In the Drawings:

REMARKS

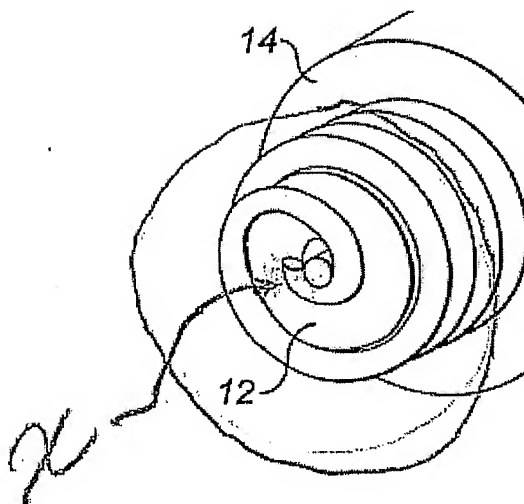
The final action rejects claims 1-6, 10-13, 15, 23 and 32 as anticipated under 35 U.S.C. §102(e) by prior art Figs. 1-2. Applicant respectfully disagrees.

Prior art Figs. 1 and 2 do not disclose the limitations in claims 23 and 32 which reads a single homogeneous wire forms both the coil and the central conductor. The term homogeneous recited in the claims means having a uniform structure. The term single means one. Thus, Applicant's recited claim limitation means that the coil and the conductor form one uniform wire.

Claim 1 makes it clear that the wire is insulated. Thus the wire is distinct from the insulation. It is the wire and not the insulation that has to be uniform. The prior art, as illustrated below, shows a point of non-uniformity at the "X". Thus the prior art does not anticipate claim 1.

To further clarify and distinguish over the art applicant has amended claim 32 to recite that a seamless conductor forms a coil and central conductor. As shown at the "X" the prior art wire is not seamless.

To further clarify and distinguish over the art, applicant has amended claim 23 to make it clear the coil 22 and central conductor 24 are a single homogenous conductor.

The prior art does not anticipate applicants claimed limitations. Accordingly, the rejection to claims 1, 23 and 32 should be withdrawn.

Fig 2.

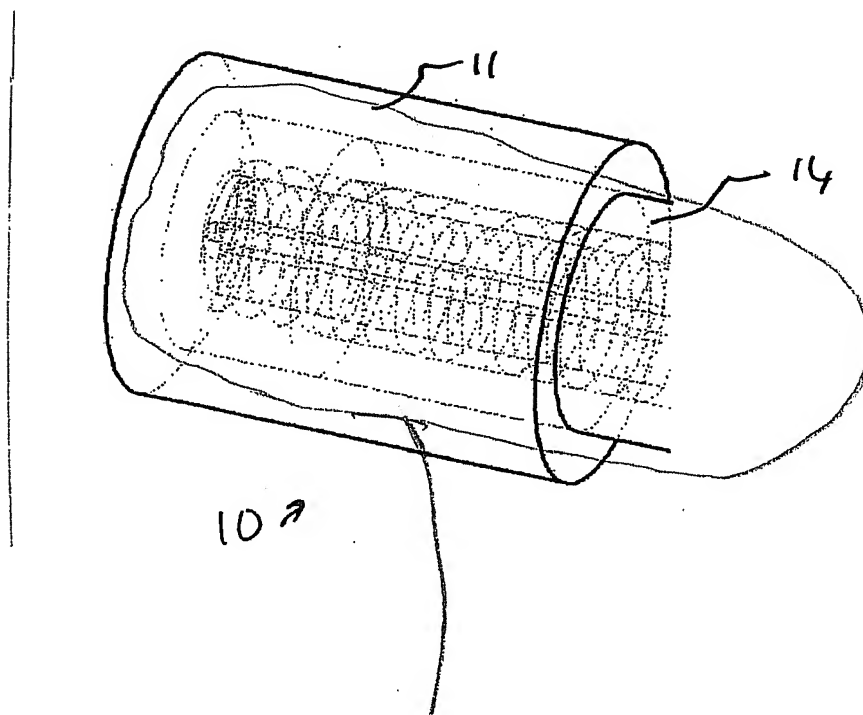
Applicant submits herewith Replacement sheet 1/2. The sheet replaces original sheet 1/4 and 2/4. Figs. 1 and 2 on Replacement Sheet 1/2 were labeled prior art. Reference numbers 18, 10 and 16 have been removed from Fig. 1. Reference number 10 has been removed from Fig. 2. Additionally, the coiling and internal structure shown in original Fig. 2 has been clarified. A marked sheet showing where the coiling and internal structure has been clarified, is attached to the action.

item clarified
